**D240002: New Zealand Transport Agency Notice of Requirement SH 1 Rolleston Access Improvements (Package 2)**

**Request for further information**

<b>Prepared for</b>	Selwyn District Council
<b>Project Number</b>	SDC-J084
<b>Revision</b>	A
<b>Issue Date</b>	10 December 2024
<b>Prepared by</b>	Mat Collins, Associate Transportation Planner; Dave Smith, Technical Director - Transportation Planning
<b>Reviewed by</b>	Dave Smith, Technical Director - Transportation Planning

Discipline:	CIVIL ENGINEERING
Drawing No.	3338703-20-CU-3500
Rev.	A

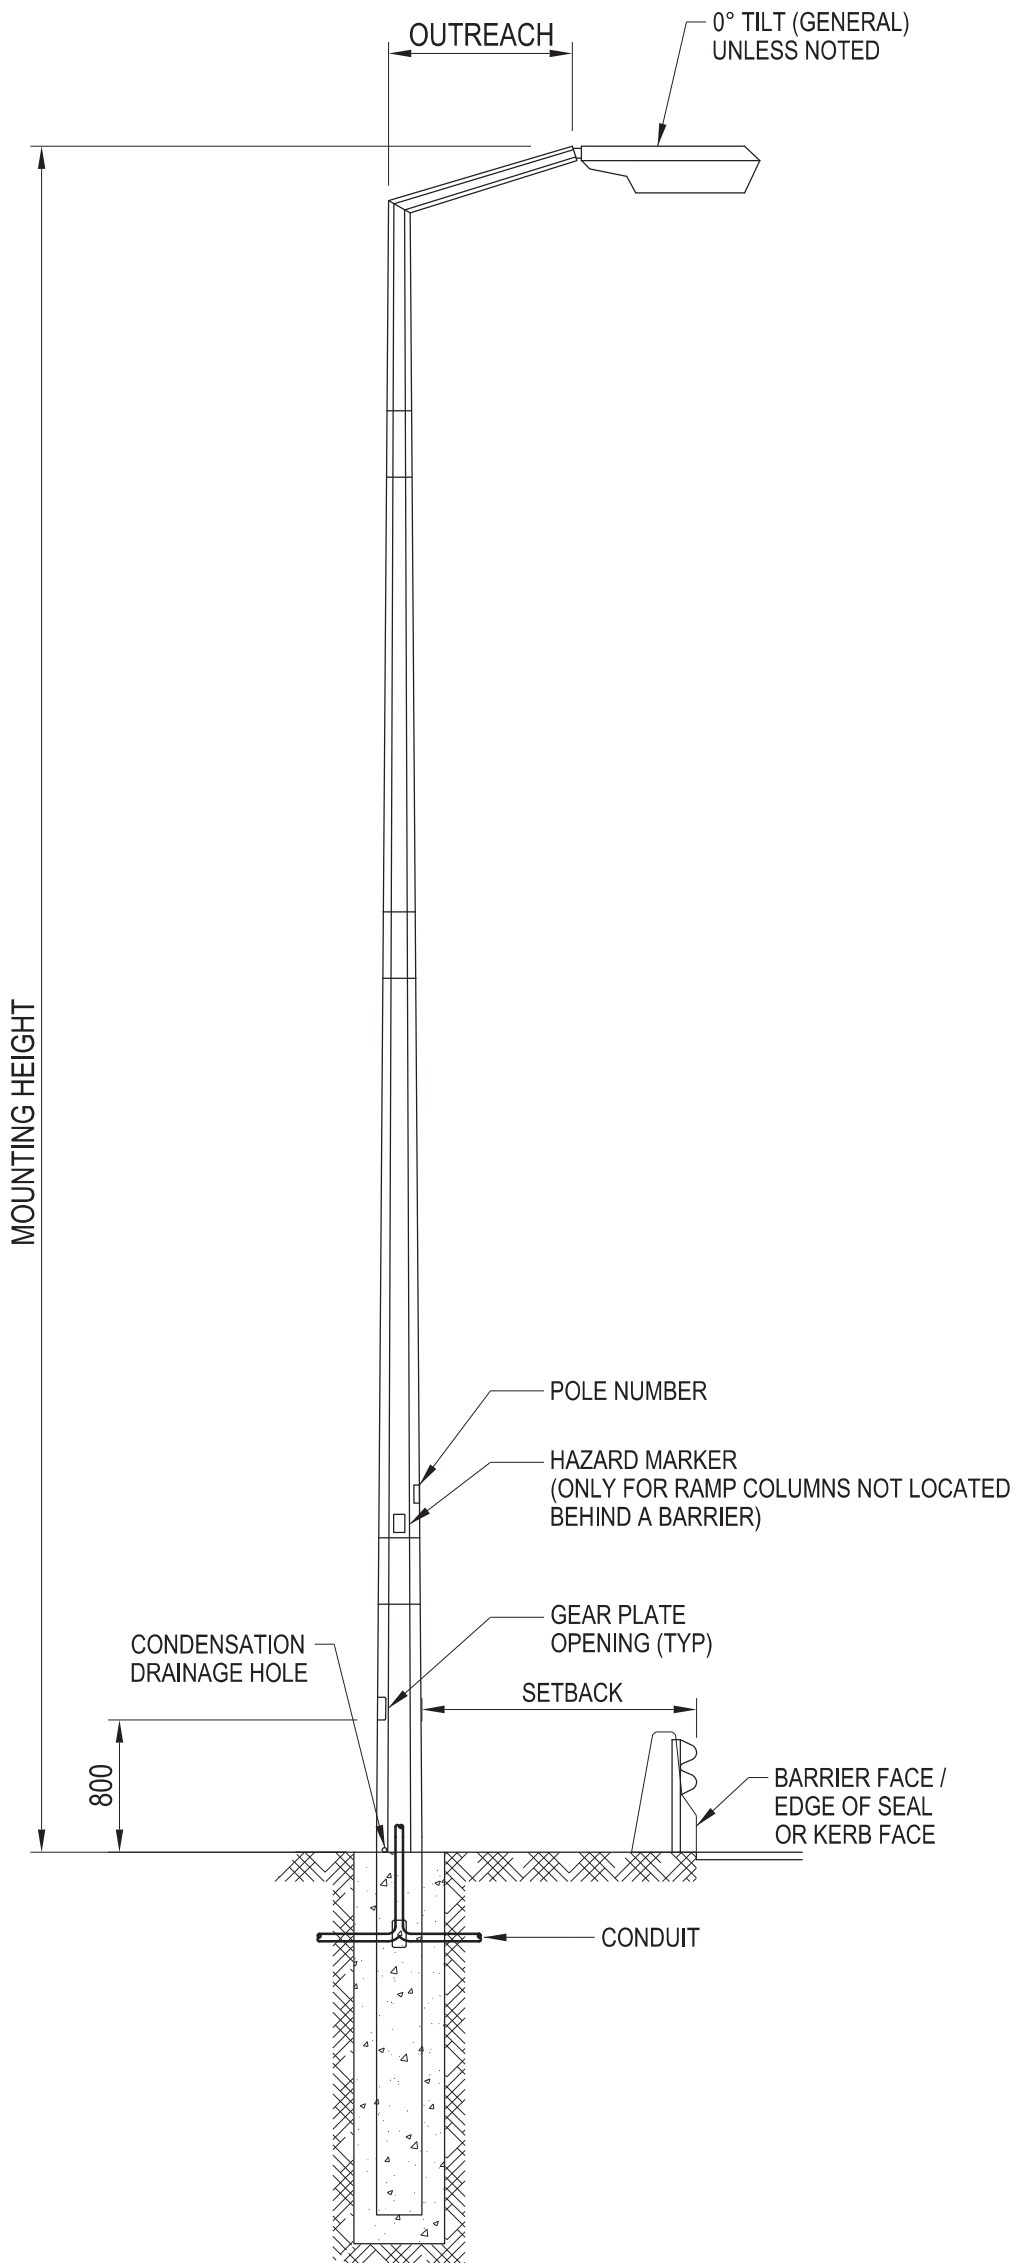
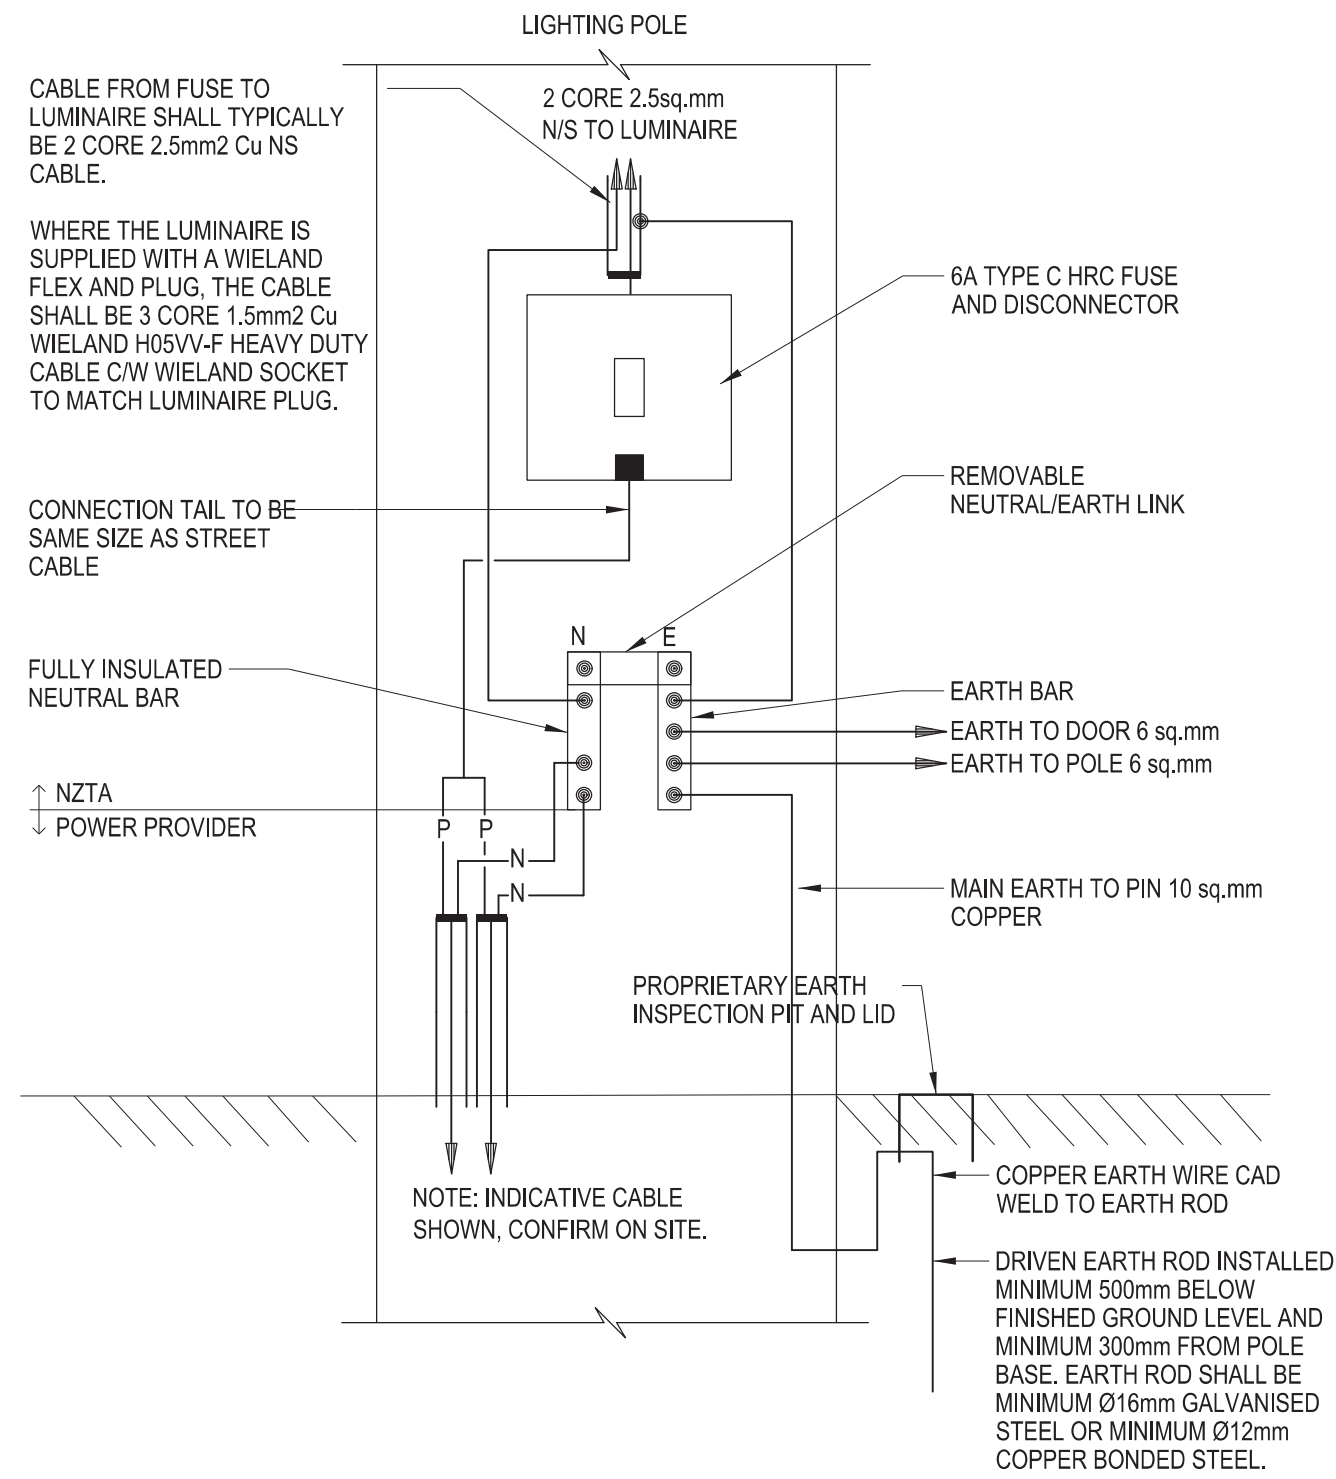
10. Drawing 3338703-20-CU-3500 - Column Type M specifies a shear based double arm lighting pole, but I believe that this arrangement won't meet the structural requirements of NZTA M26, whereas a ground planted double arm pole will. *This is not being noted as a lighting design non-compliance; however, I think it would be prudent for the lighting designer to check with the pole supplier to confirm that the requirements of NZTA M26 are met with the proposed double arm lighting pole.*

11. Drawing 3338703-20-CU-3500 - Note 6 specifies a shorting cap to be fitted to each luminaire, however NZTA M30 (NZTA Specification and Guidelines for Road Lighting Design) requires that a CMS system is considered. The use of a shorting cap will require the power supply to be controlled by the local electricity company where they will switch the luminaires on and off remotely by whatever system they employ. Whereas a CMS system will require a Light Point Controller (LPC) to be installed on each luminaire where the switching and dimming is controlled via the CMS system. *Please get the lighting designer to confirm that NZTA is happy with the use of shorting caps on each new luminaire.*

I don't think you can get a multi-arm lighting pole to be slip base and comply with NZTA M26. To meet the M26 requirements the pole needs to be ground planted. Please check with the pole supplier for confirmation.

Discipline: CIVIL ENGINEERING  
Drawing No: 3338703-20-CU-3521  
Rev: A

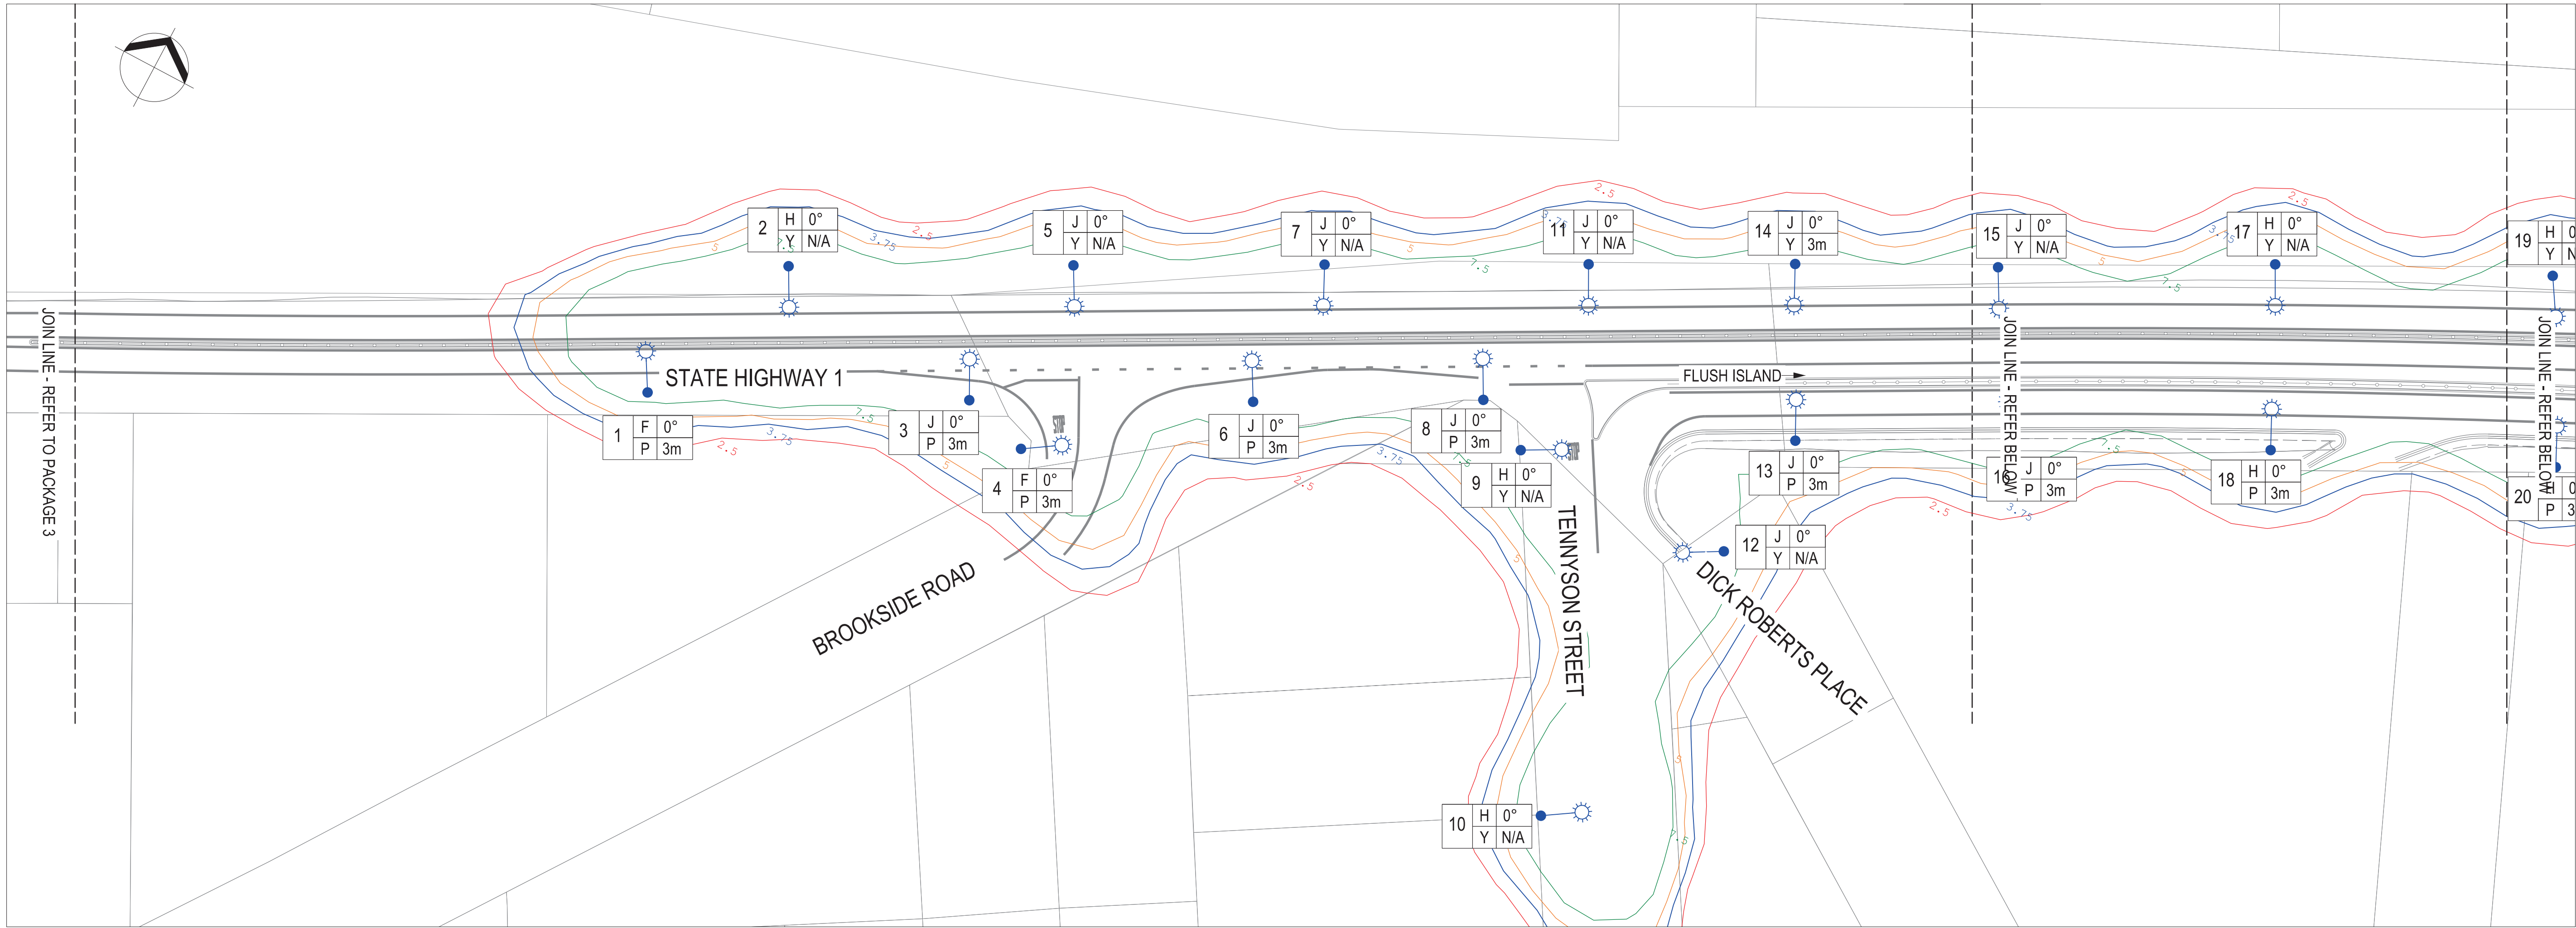
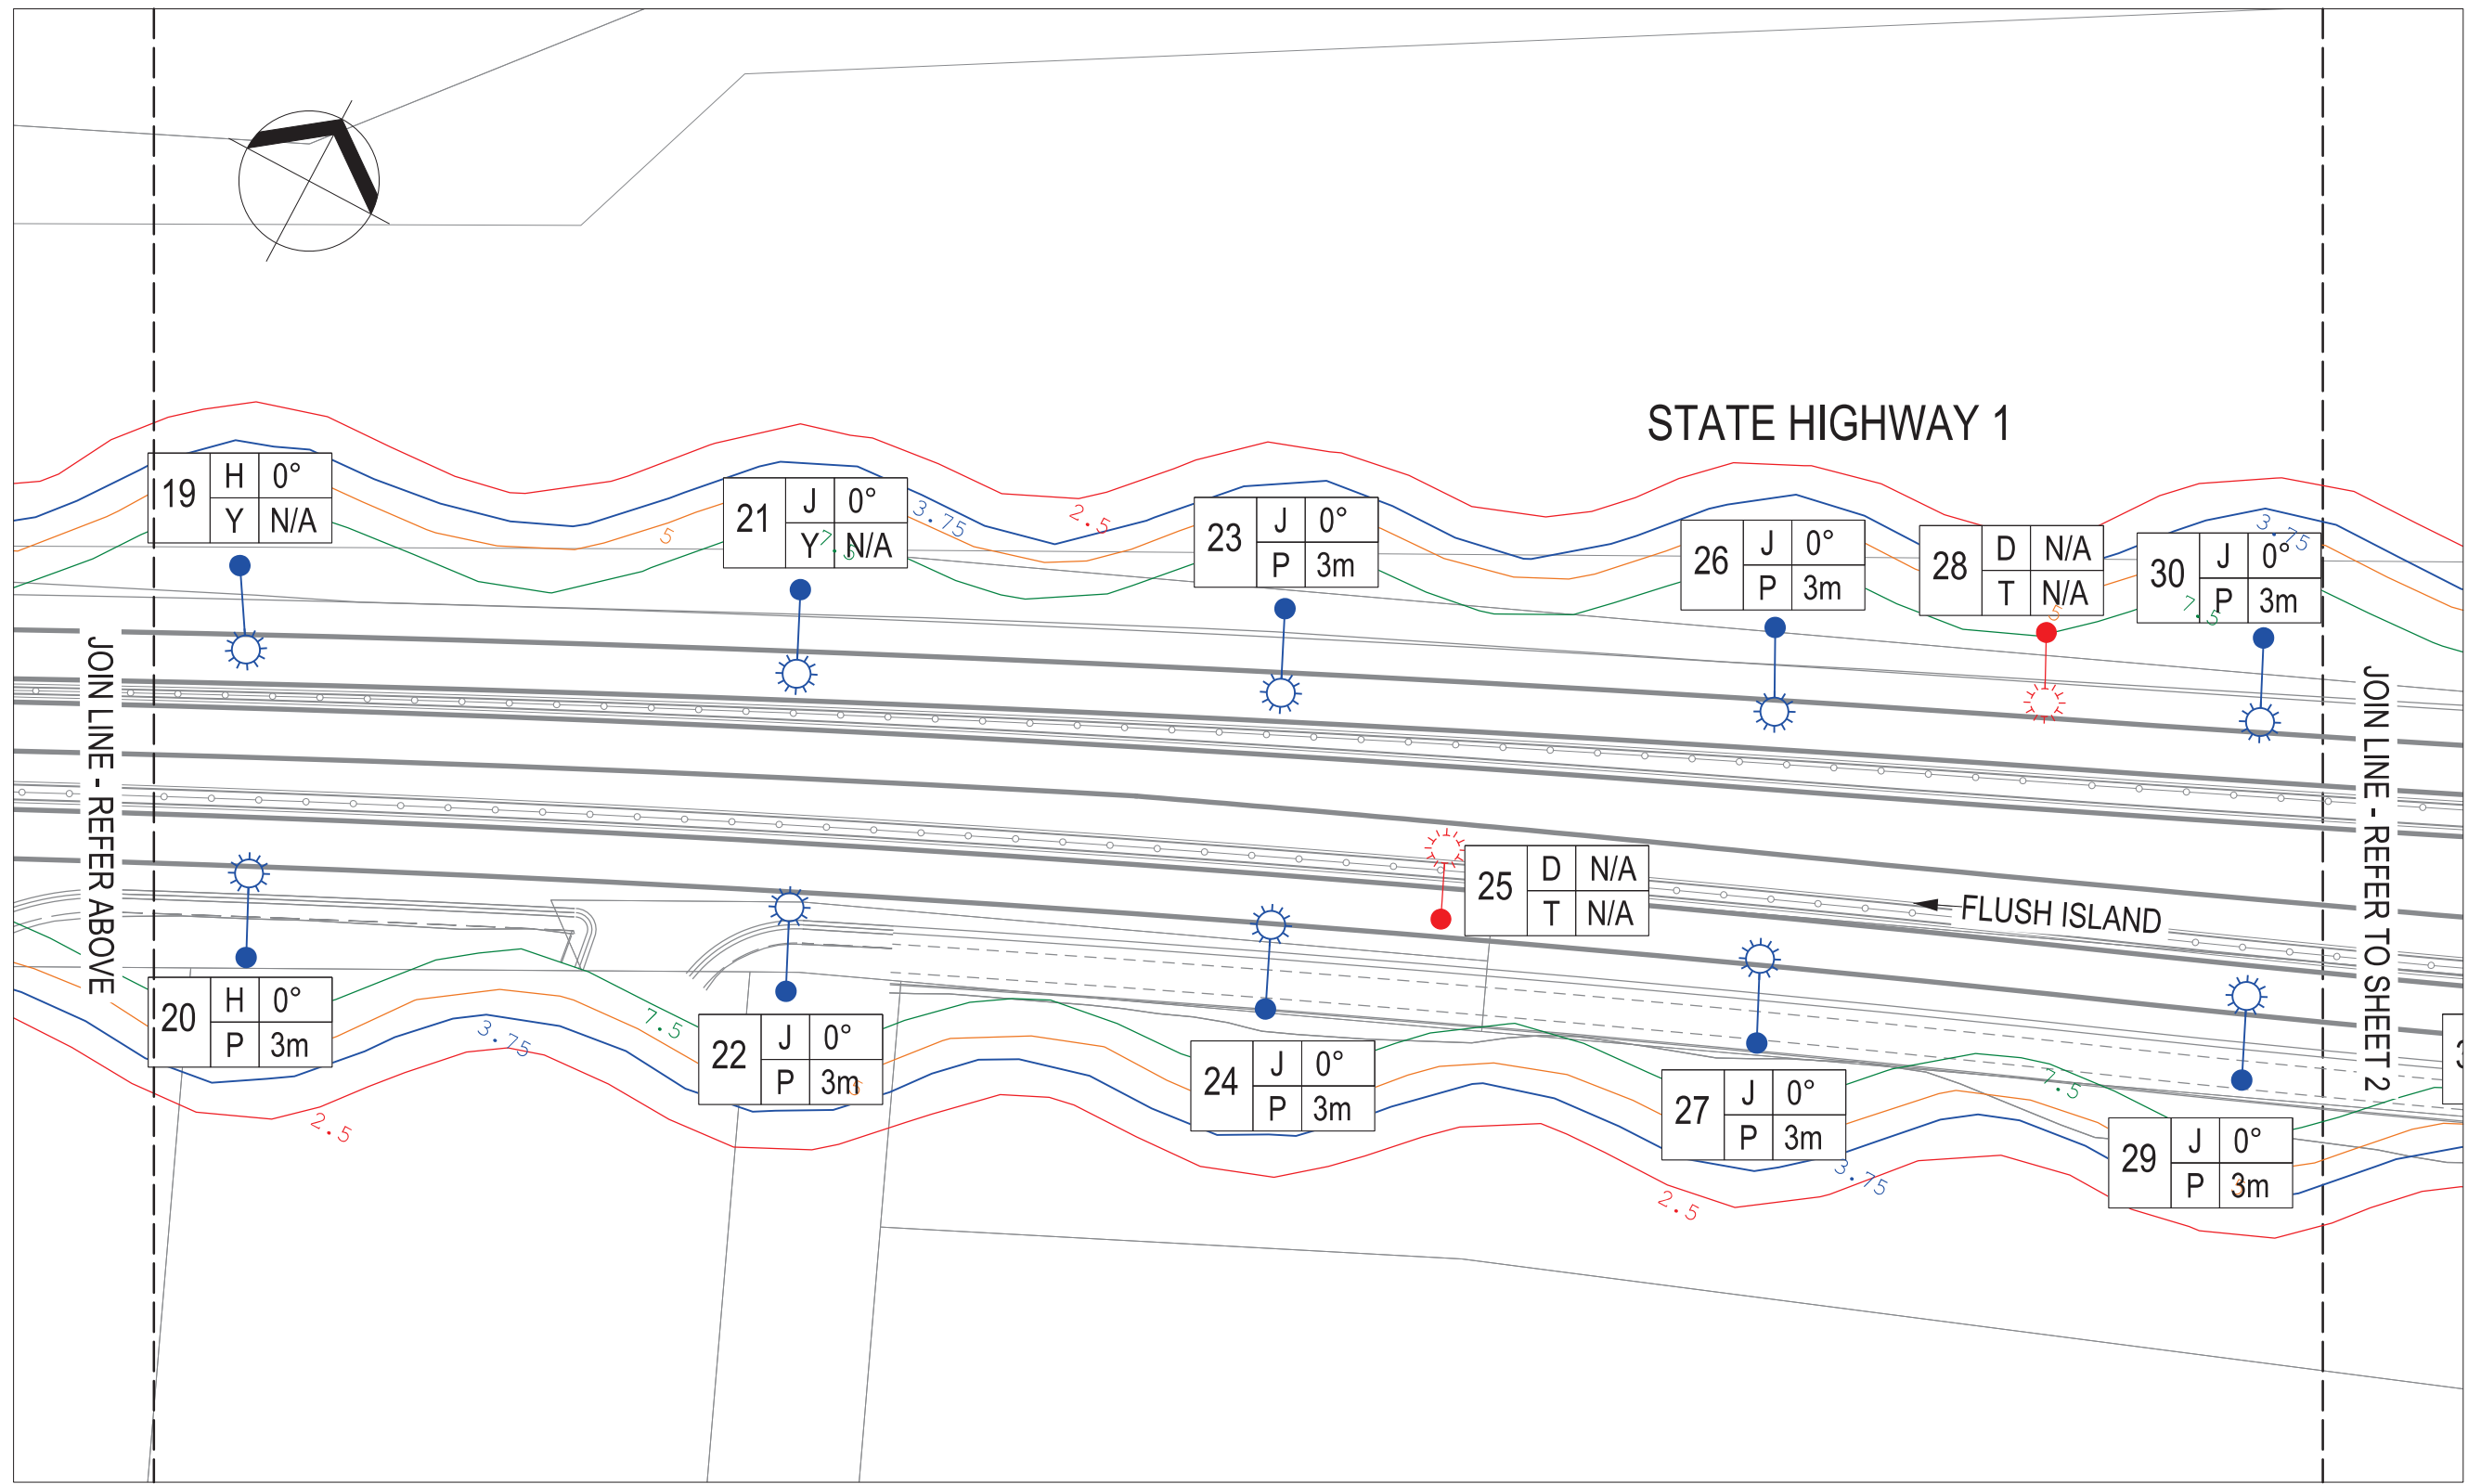
12. Drawing 3338703-20-CU-3521 - Calculation Summary table presents one set of luminance calculation results, but what lane configuration does this calculation apply to? There appears to be single lanes diverging into double lanes and double lanes merging into single lanes. There needs to be multiple luminance calculations to account for the different lane configurations. *Please get the lighting designer to confirm that the luminance calculations apply to all of the lane configurations (4-lane and 2-lane divided carriageways) or supply additional calculation results to cover all arrangements.*

13. Drawing 3338703-20-CU-3521 - Calculation Summary table presents illuminance and uniformity calculations for the SH1 northbound diverging lanes, but according to the north symbol on the drawing the diverging lanes are going in an easterly direction, also where are the calculations for the westbound merging lanes on the other side of SH1? *Please get the lighting designer to change the lane directional description so that it aligns with the true geographic direction. Please get the designer to include illuminance calculations for the westbound merging lanes.*

14. Drawing 3338703-20-CU-3521 - Calculation Summary table presents illuminance and uniformity calculations for the Brookside and Tennyson intersections, and lane divergence, but these appear to be limited to the carriageway areas...where are the calculations for the surrounds? *Please get the lighting designer to provide calculations for all applicable design areas (carriageways and surrounds) at all locations in accordance with AS/NZS 1158.1.1 Figures 4.2, 4.4, 4.8 and 4.10.*

What lane configuration does this calculation apply to? SH1 appears to have single lanes diverging into double lanes and double lanes merging into single lanes, so the calculation needs to account for all lane configurations.
